## ORIGINATION FORM

Proposed Revisions to a Standard Plans Index  
(Please provide all information — Incomplete forms will be returned)

Index Number: 515-062  
Sheet Number (s): 6  
Index Title: Pedestrian/Bicycle Railing (Aluminum)

Sheet 6- Added knuckled selvage as an option to the chain-link railing option

**TYPE 2 - CHAIN-LINK (Continuous Infill Panel)**

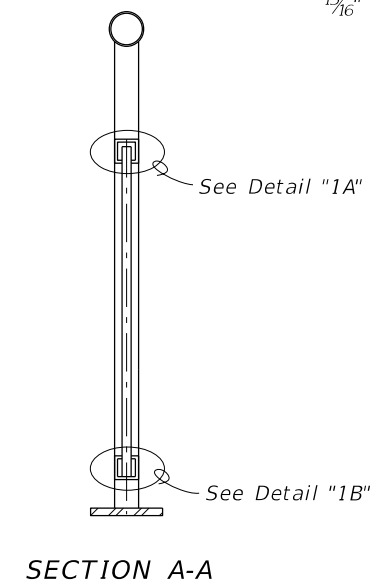
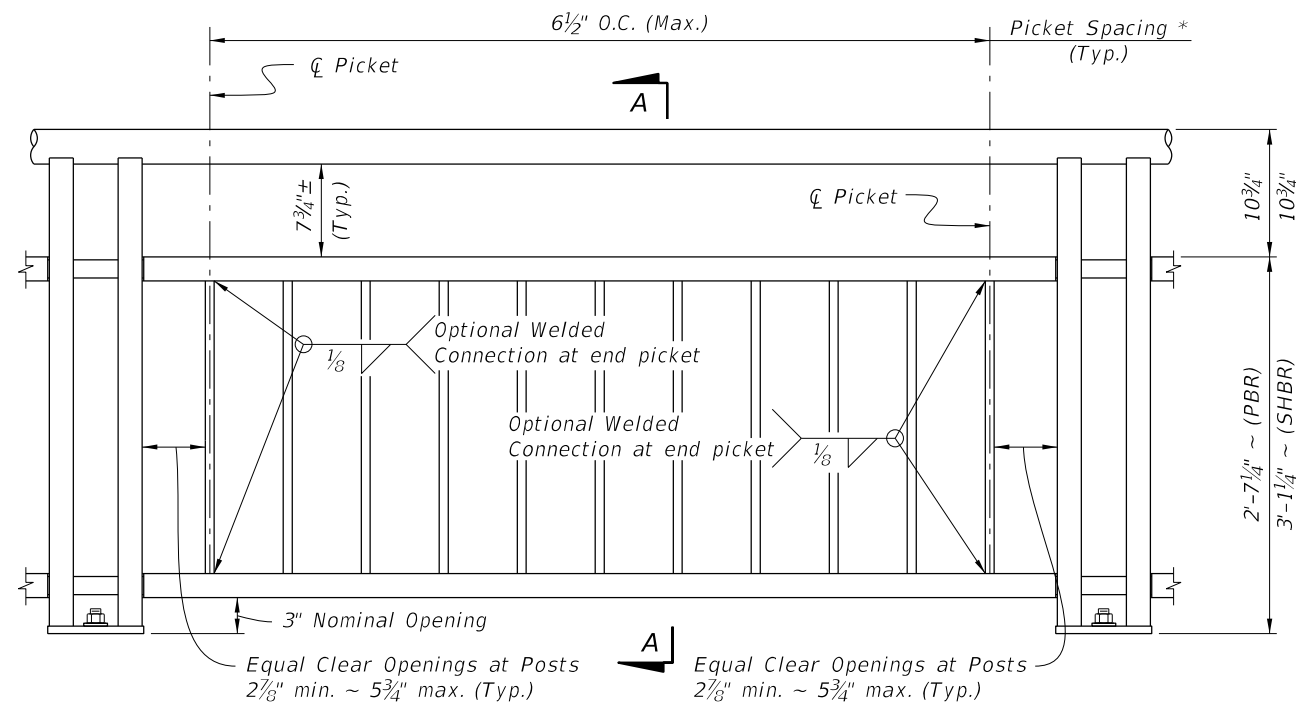
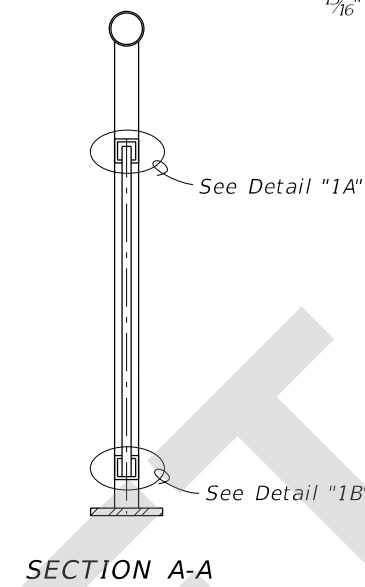
The selvage requirements detailed on Index 515-062 were based on a conservative approach to secure the bottom edge. Using knuckle selvage top and bottom would be acceptable.

TABLE 2 - CHAIN-LINK PANEL COMPONENT MATERIALS		
COMPONENT	ASTM	COMPONENT INFORMATION
Chain-Link Fence Fabric (2" mesh with <del>twisted bottom and knuckled top selvage</del> )	A392	Zinc-Coated Steel - No. 9 gage (coated wire diameter), Class 2 Coating
	A491	Aluminum-Coated Steel - No. 9 gage (coated wire diameter)
	F668	Polyvinyl Chloride (PVC) Coated Steel - No. 9 gage Zinc-Coated Wire (metallic-coated core wire diameter) ~ See Plans for specified color of PVC.
Tie Wires	F626	Zinc-Coated Steel Wire - No. 9 gage with coating to match Chain-Link Fence Fabric.
Tension Bars	F626	3/16" (min. thickness) x 3/4" (min. width) x 2'-3' (min. height) Steel Bars
Miscellaneous Fence Components	F626	Zinc-Coated Steel

TABLE 2 - CHAIN-LINK PANEL COMPONENT MATERIALS		
COMPONENT	ASTM	COMPONENT INFORMATION
Chain-Link Fence Fabric (2" mesh with knuckled and top bottom selvage)	A392	Zinc-Coated Steel - No. 9 gage (coated wire diameter), Class 2 Coating
	A491	Aluminum-Coated Steel - No. 9 gage (coated wire diameter)
	F668	Polyvinyl Chloride (PVC) Coated Steel - No. 9 gage Zinc-Coated Wire (metallic-coated core wire diameter) ~ See Plans for specified color of PVC.
Tie Wires	F626	Zinc-Coated Steel Wire - No. 9 gage with coating to match Chain-Link Fence Fabric.
Tension Bars	F626	$\frac{3}{16}$ " (min. thickness) x $\frac{3}{4}$ " (min. width) x 2'-3' (min. height) Steel Bars
Miscellaneous Fence Components	F626	Zinc-Coated Steel
